In the Matter of PacifiCorp's 2021 Integrated
Resource Plan

Docket No. 21-035-09

Sierra Club's Opening Comments

Figure 1. Historic Henry Hub Prices and PacifiCorp's IRP Natural Gas Price Forecast

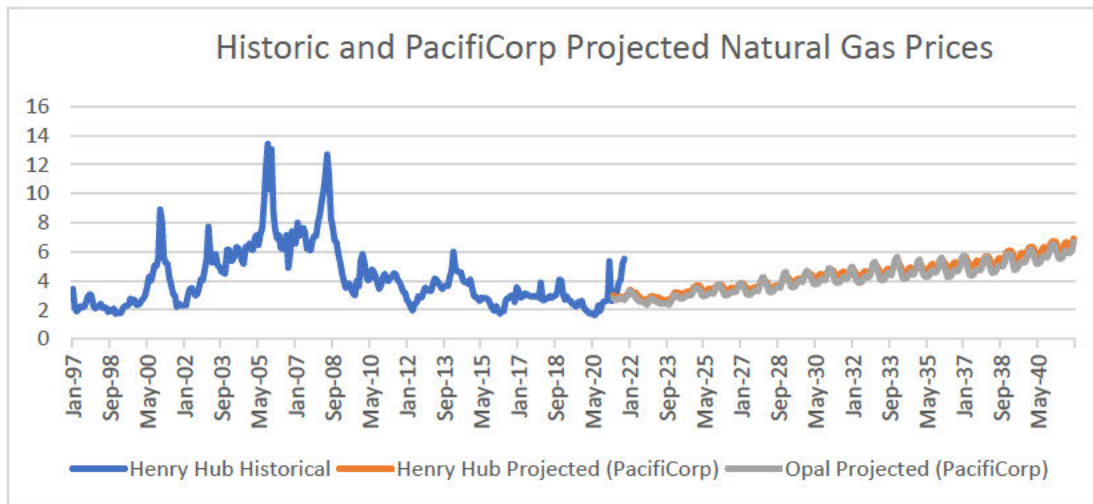
PacifiCorp's IRP forecast expects these low prices to continue for the entire planning horizon. As shown in Figure 1, PacifiCorp's forecast for Henry Hub natural gas prices begins in April 2021 at just under \$3/MMBtu, slowly rise to \$4 in 2029, \$5 in 2034, and ultimately top off at just under \$7/MMBtu by 2041.⁷⁶

Figure 2. Henry Hub Prices Since January 2020, and PacifiCorp's Gas Price Forecast

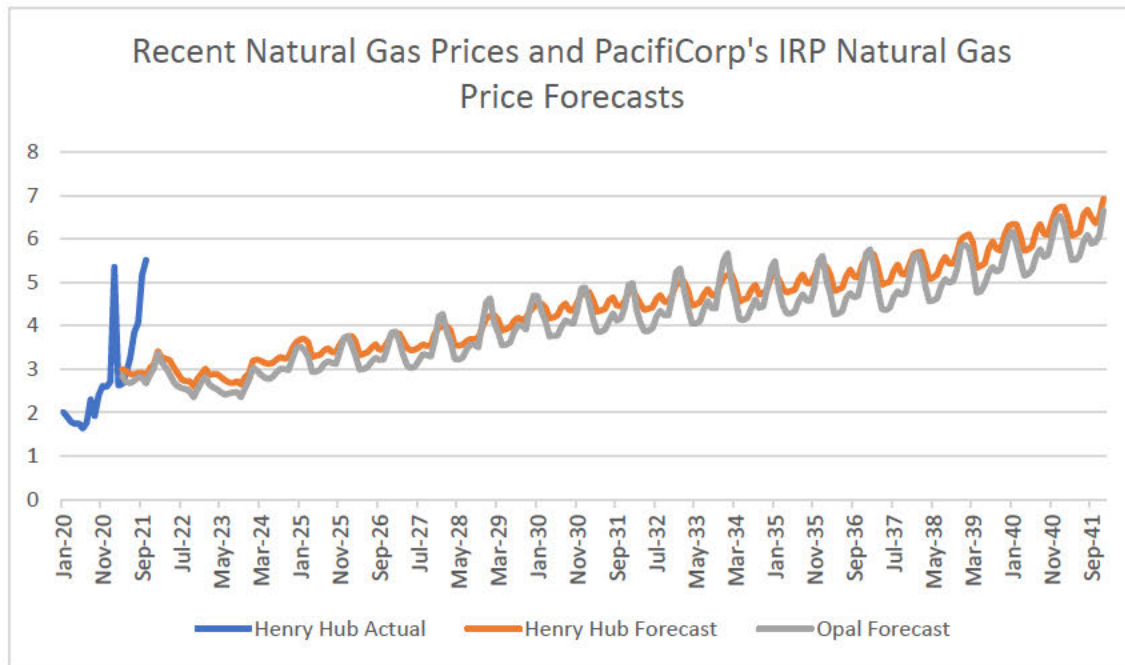
However, gas prices have nearly doubled in the past year alone.⁷⁷ Prices rose sharply in February 2021 after the Texas winter storm, dropped quickly, but then immediately started a persistent climb in March 2021 until today. Because PacifiCorp had to lock in its gas price forecast as an input for its IRP in early 2021, we can track the Company's forecast to actual gas prices. Since April 2021, actual gas prices have significantly increased relative to the Company's forecast. In October 2021, the Henry Hub price for gas was \$5.51/MMBtu, nearly double the Company's forecast of \$2.84/MMBtu.

Figure 3. U.S. Natural Gas Production

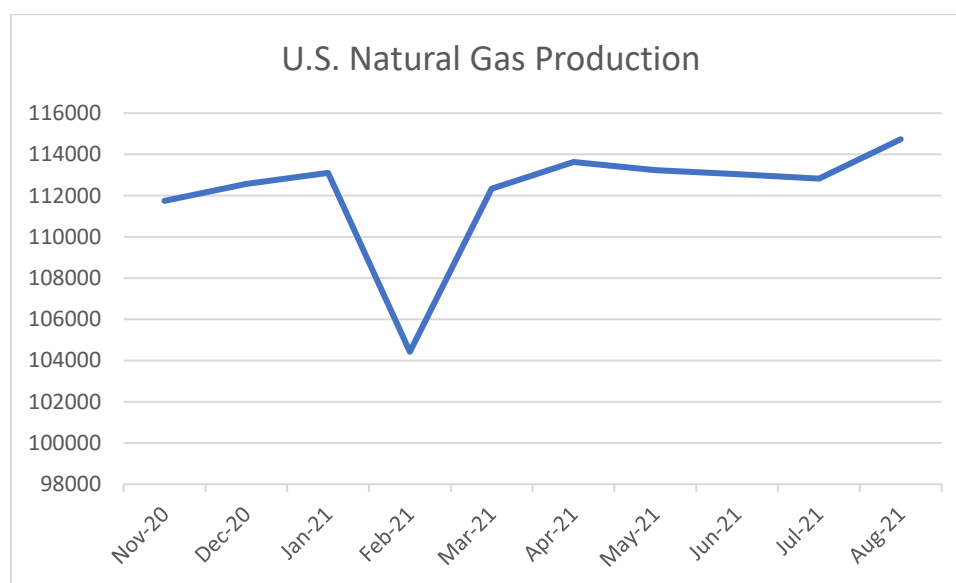
However, even as gas prices reached and then exceeded \$3.17/MMBtu in 2021, rather than incentivizing drillers to chase production as PacifiCorp predicted, domestic fracked gas production has remained relatively flat since November 2020.⁸⁰
